SUBJECT: Safety Recall 07S57:
Certain 1997 - 2003 F-Super Duty, Excursion, and E-Series Vehicles
Equipped with 7.3L Diesel Engines
Camshaft Position (CMP) Sensor Inspection / Replacement

CERTAIN 1997-2003 MODEL YEAR F-SUPER DUTY, EXCURSION AND E-SERIES EQUIPPED WITH A 7.3L DIESEL — CAMSHAFT POSITION (CMP) SENSOR INSPECTION AND/OR REPLACEMENT

FIGURE 1

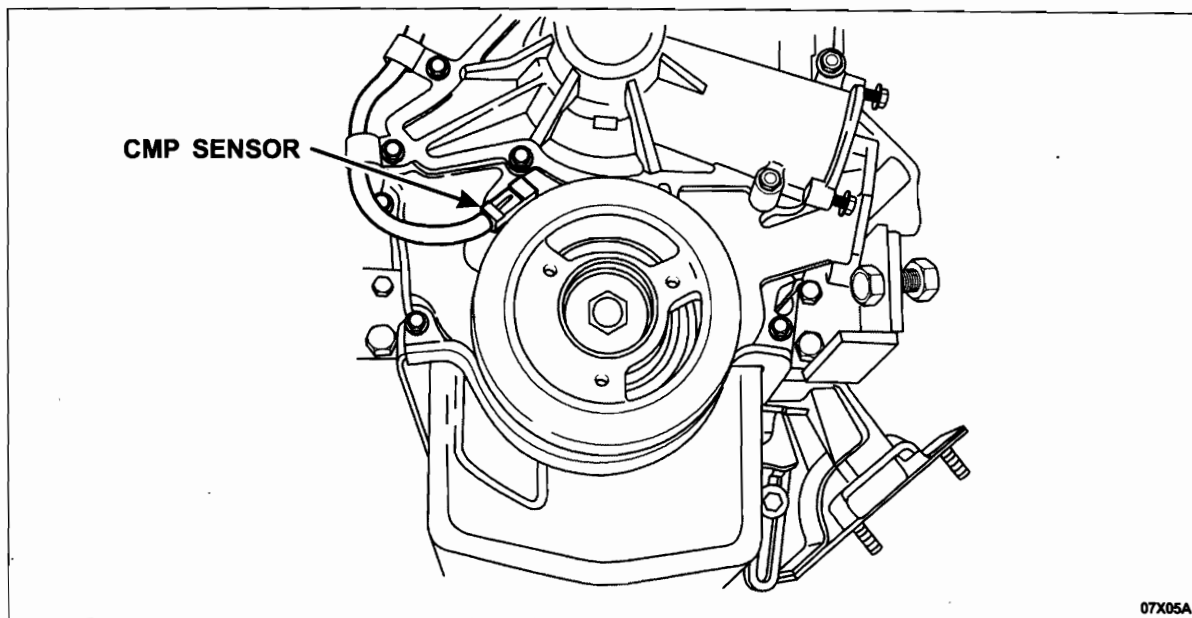
1. With the vehicle in NEUTRAL, position it on a hoist.
2. Inspect the color of the CMP sensor and bracket assembly. See Figure 1 for location of the CMP sensor.
 - ***If the CMP sensor is gray with a silver bracket, no action is required.***
 - ***If the CMP sensor is black with a gold bracket, proceed to the Service Procedure.***

1. Disconnect the wiring harness connector at the CMP sensor.
2. Remove the retaining bolt and the CMP sensor and bracket assembly.
3. Install a **new** CMP sensor and bracket assembly and retaining bolt. Tighten the retaining bolt to 24 Nm (18 lb-ft).
4. Connect the wiring harness connector to the CMP sensor.
